Minimoog service manual errata

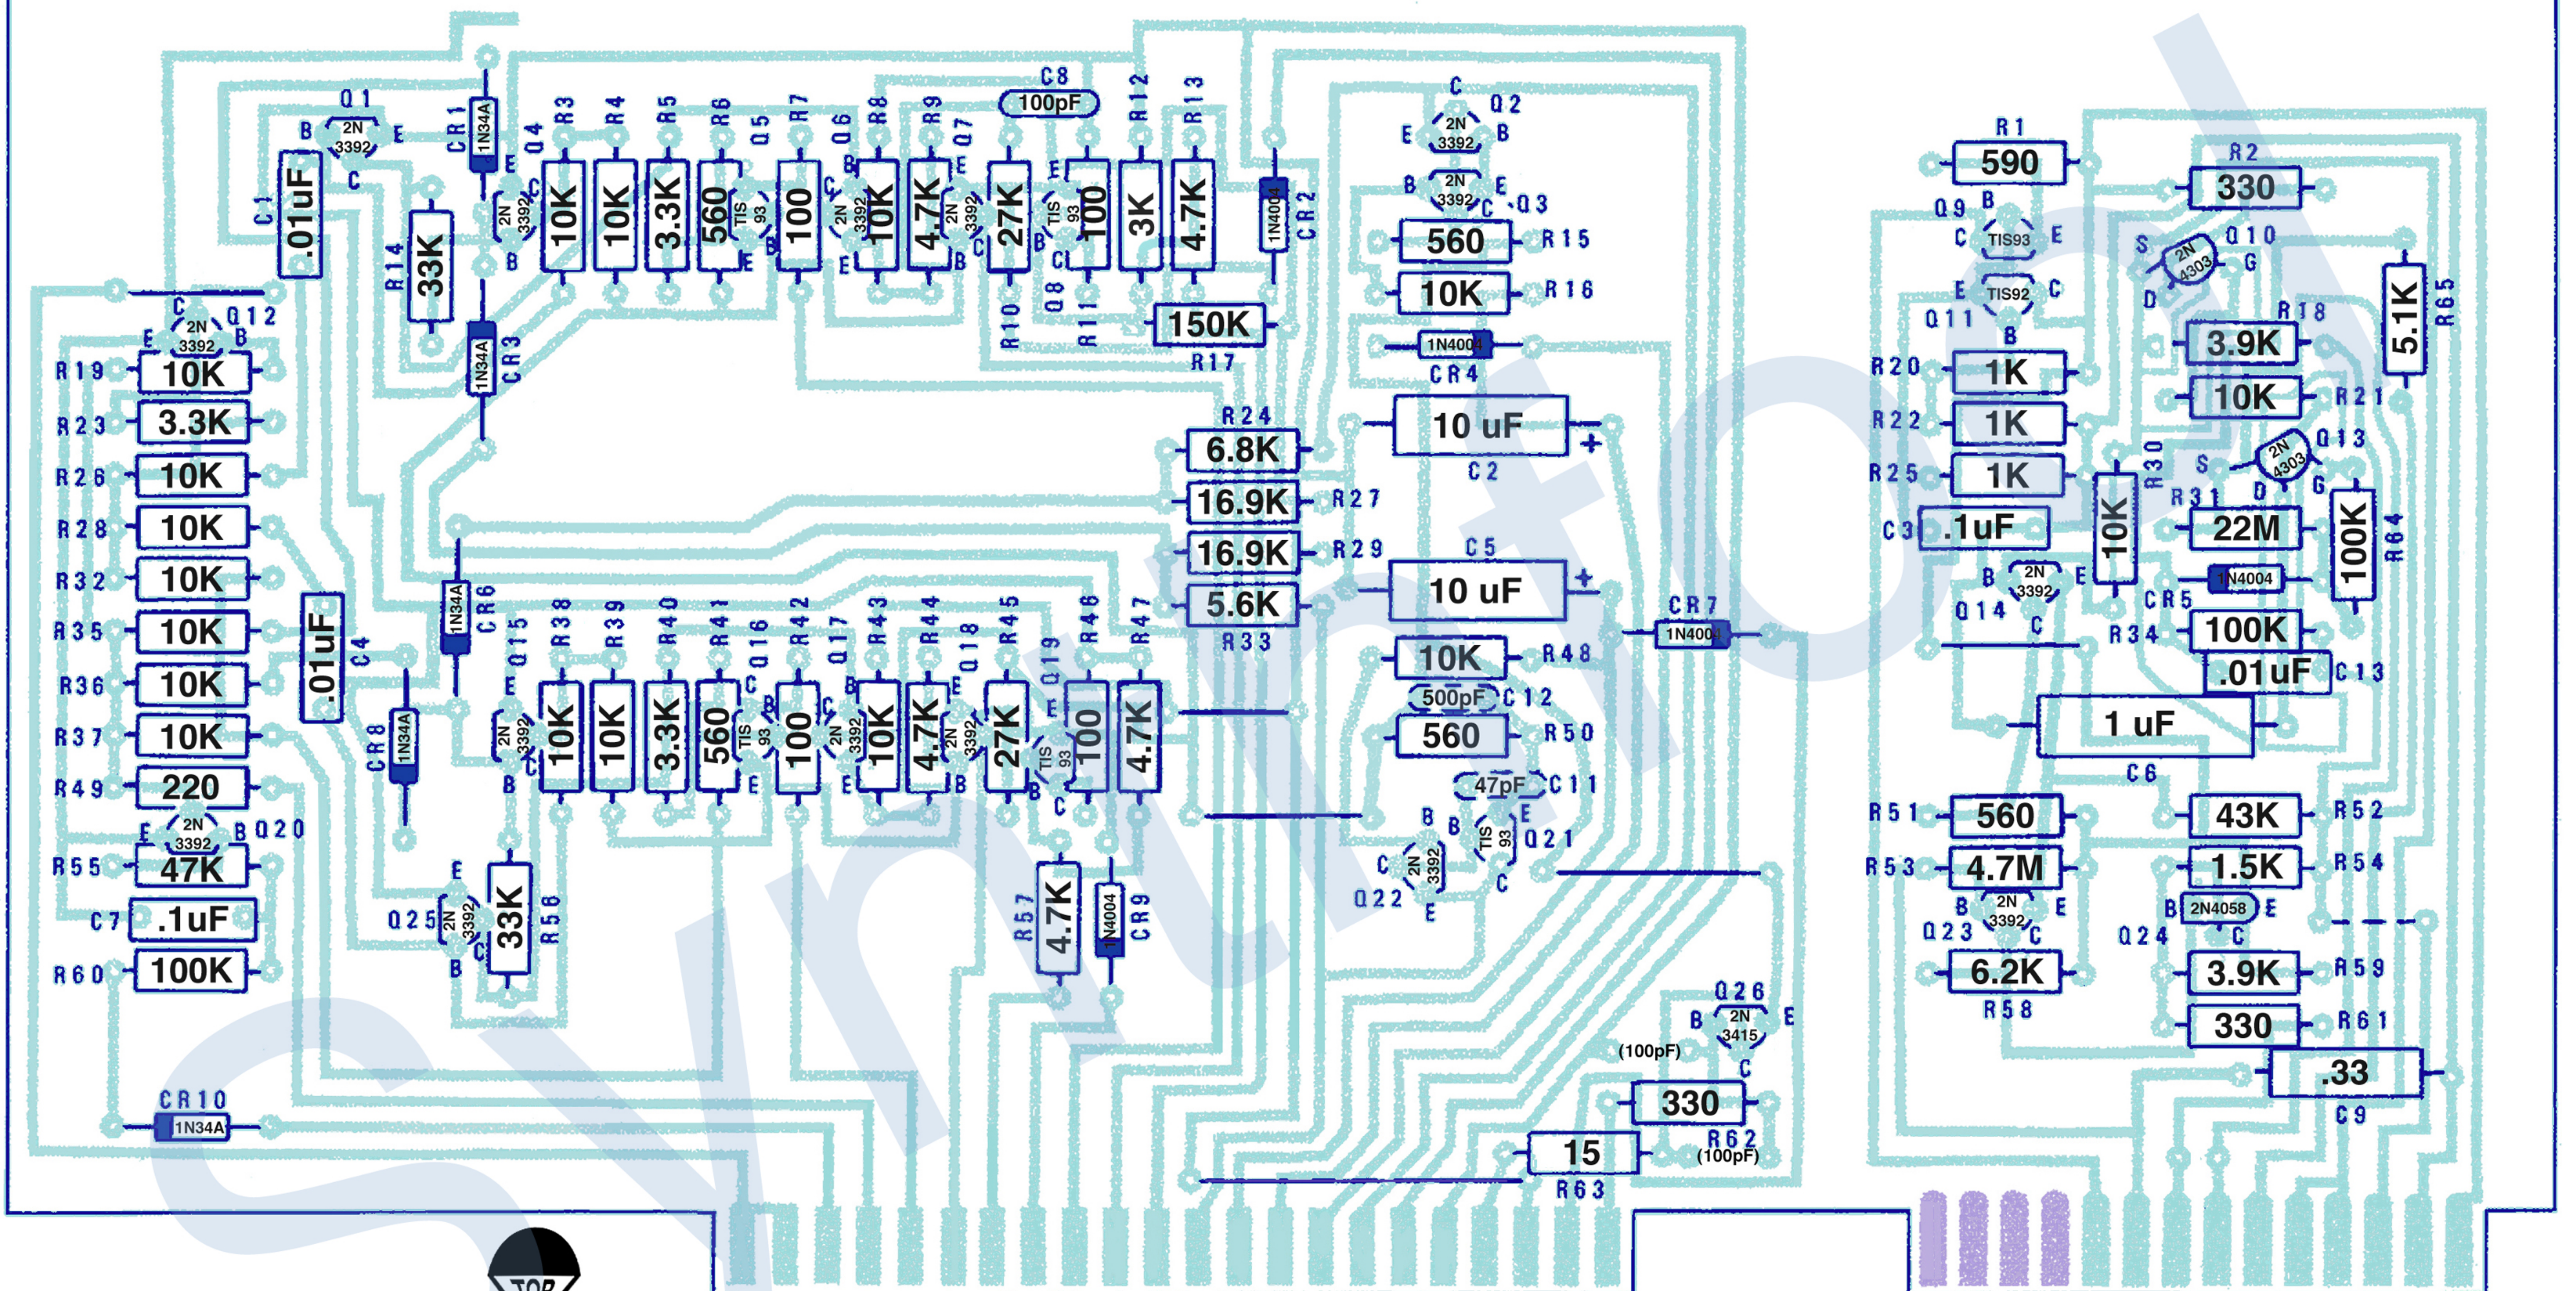
Changes regarding oscillator range switches.

1st edition: 10 ohm resistors, no current loop resistor, no buffer board, old VCOs

2nd edition: 1K ohm resistors, 90.9 ohm current loop resistor, no buffer board, old VCOs

3rd edition: 1K ohm resistors, 90.9 ohm current loop resistor, buffer board, old VCOs

4th edition: 1K ohm resistors, no current loop resistor, buffer board, new VCOs

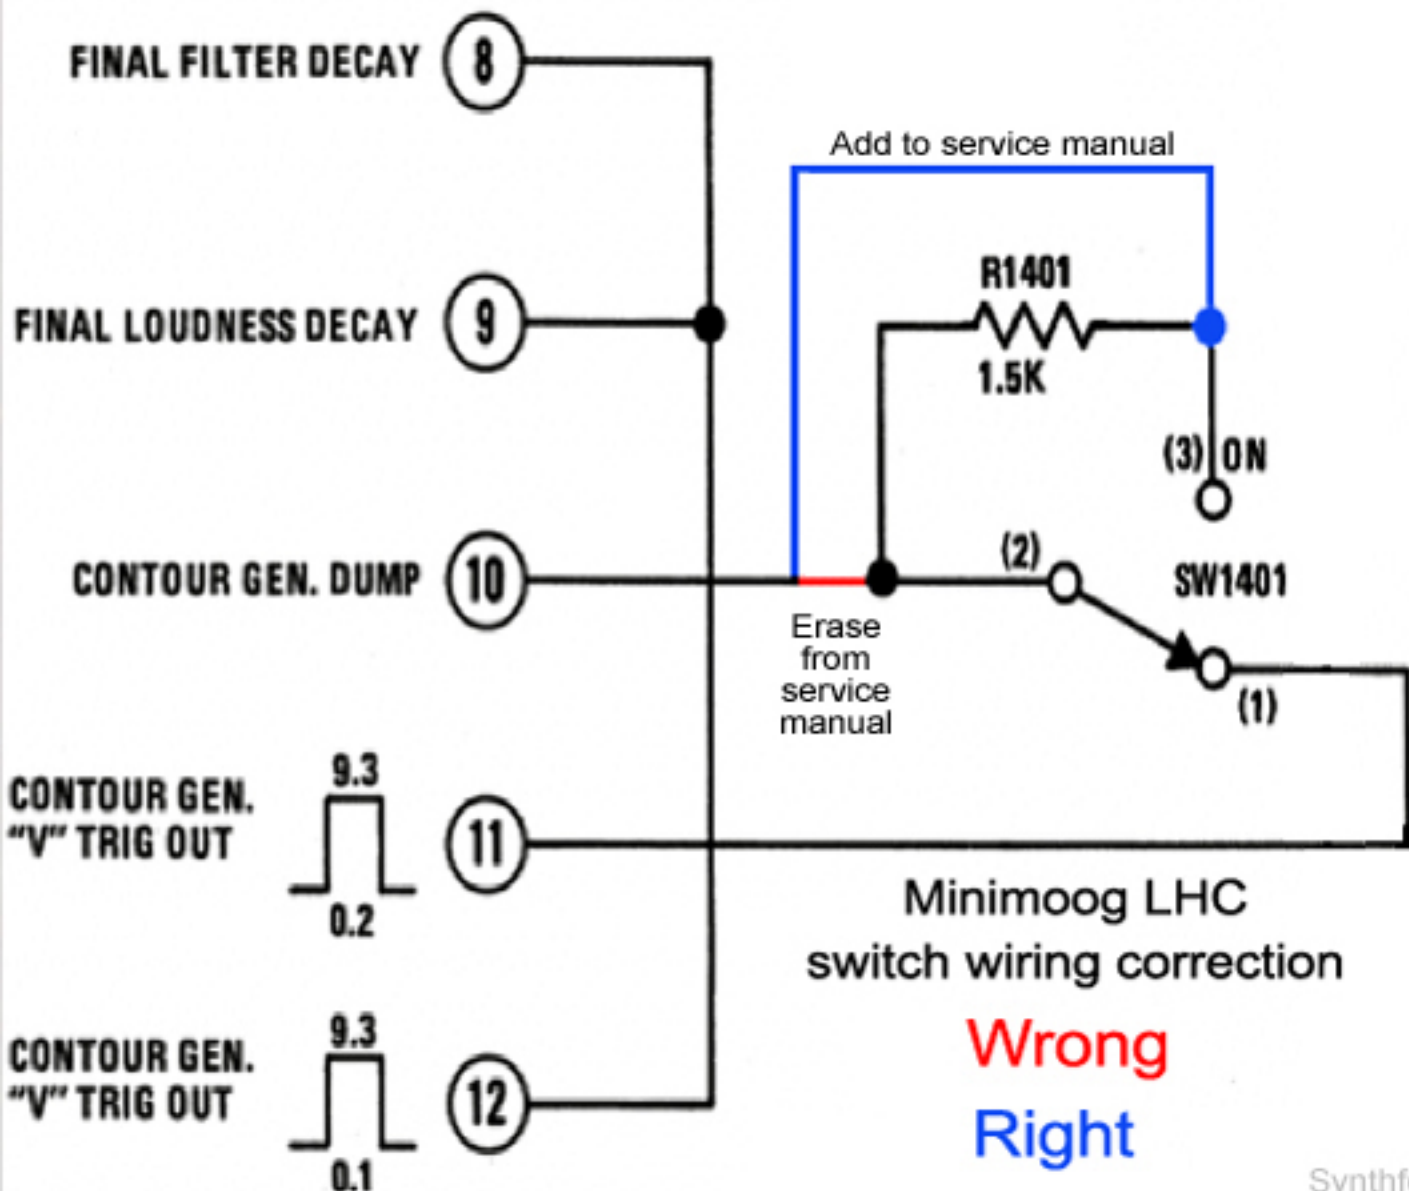
R34 IS 5.1K ON EARLY UNITS. REPLACE WITH 100K AND ADD C13.
 R64, R65 AND C13 NOT PRESENT ON EARLIER UNITS. ADD ALL.
 C8 NOT PRESENT ON SOME EARLY UNITS. ADD 100PF.
 100PF CAPS ADDED ON SOME UNITS NEAR R62 AND R63.
 C11 AND C12 ADDED ON SOME UNITS NEAR R50 AND Q21.
 R62 IS 100 OHMS ON VERY EARLY UNITS

TO FIX VCF ENV ATTACK UNDERSHOOT, REPLACE R13 WITH SELECTED
 RESISTOR (~3.7K) OR REPLACE R12 WITH 25K TRIMMER
 TO ADD ADJUSTABLE KEY CURRENT (SCALING), REPLACE R1 WITH
 560 OHM 1% AND 50 OHM CERMET TRIMMER IN SERIES.
 IF GLIDE TIMES UP AND DOWN ARE NOT EQUAL, SELECT R59 VALUE
 TO INCREASE GLIDE TIME TO 10 SECS MAX, REPLACE C6 WITH 3.9UF

R39 Changed to 511 ohms on later units

Change R34 to 300 ohms if installing
a 20 ohm multiturn for R21

C13 incorrectly marked as .01uf in schematics

R44 shown twice in schematics

R41 (misabeled as R44) is 10 ohm near Q16

Change R60 for variable modulation depth

Later boards (shown) have noise circuitry changes.
Old boards will have R19 as 6.8megs and other changes
around R67.
